# ADDENDUM No. 2 TO THE CONTRACT DOCUMENTS

**Project:** Captain's Bay 35kV Line Extension

Addendum Issue Date: May 11, 2017

"Drawing E1.14"

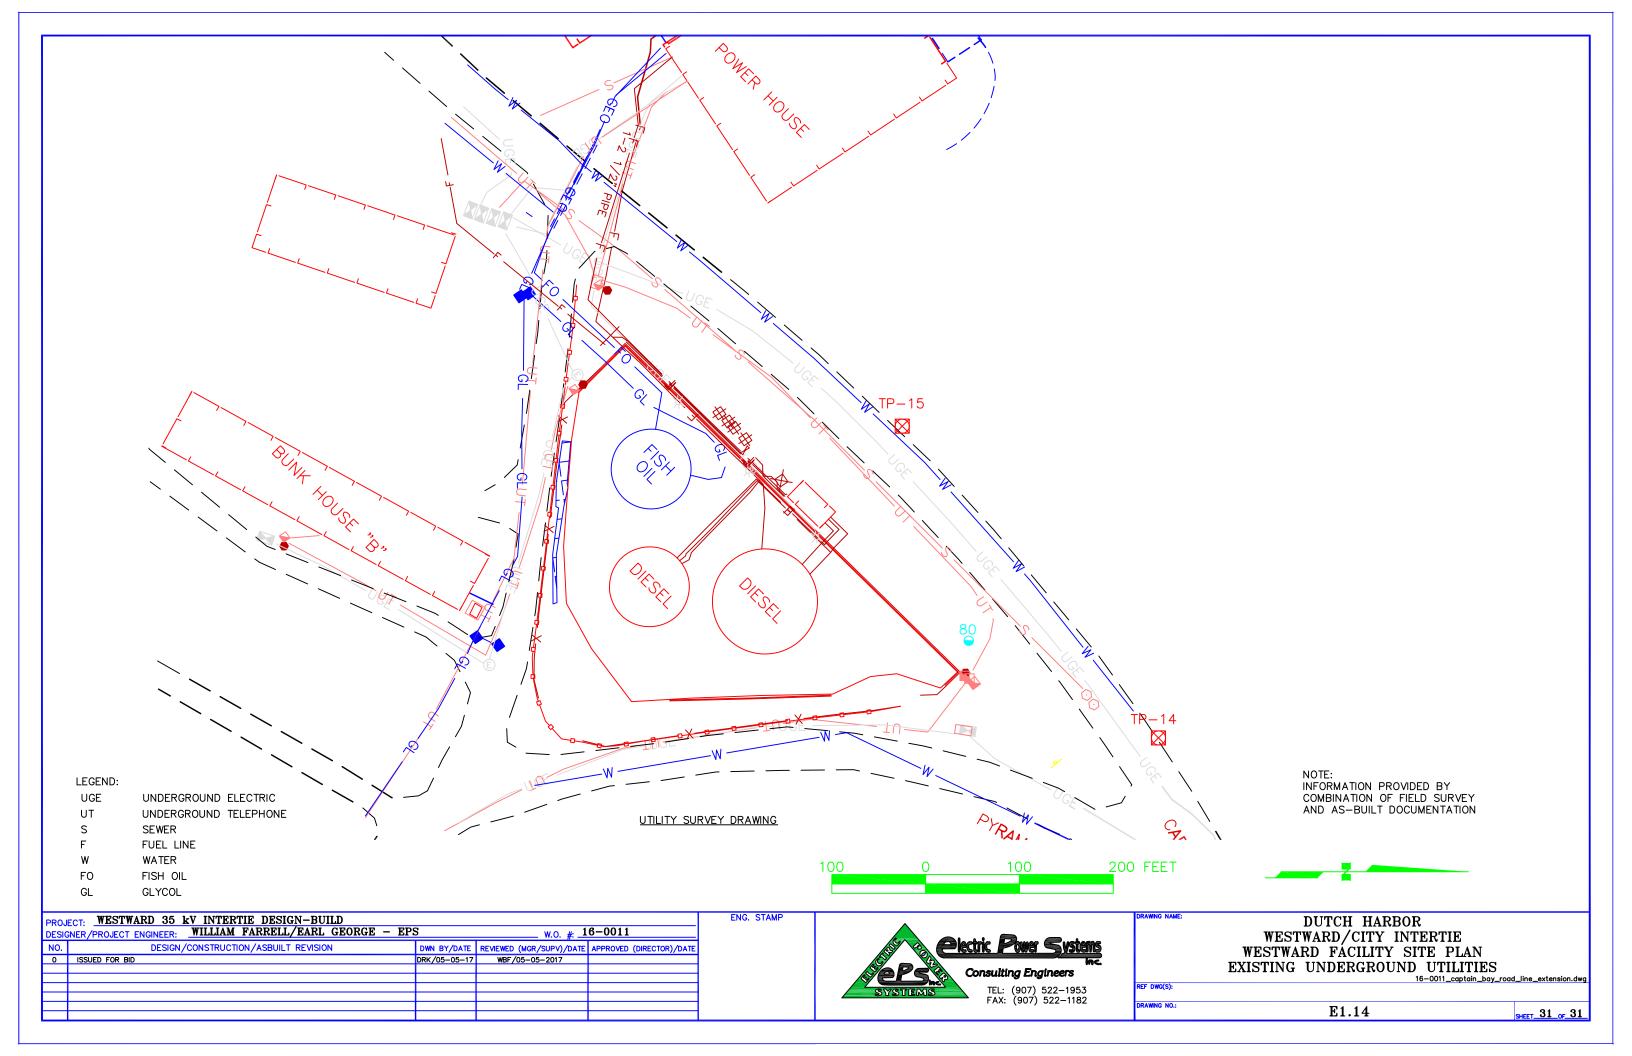
The attached drawing E1.14 has been added to the plans set in order to provide further detailed information regarding existing utilities located at and around the Westward Seafoods Captain's Bay facility. Facilities in this area are owned by Westward, North Pacific Fuel and the City of Unalaska. Requirements for obtaining locates are not changed.
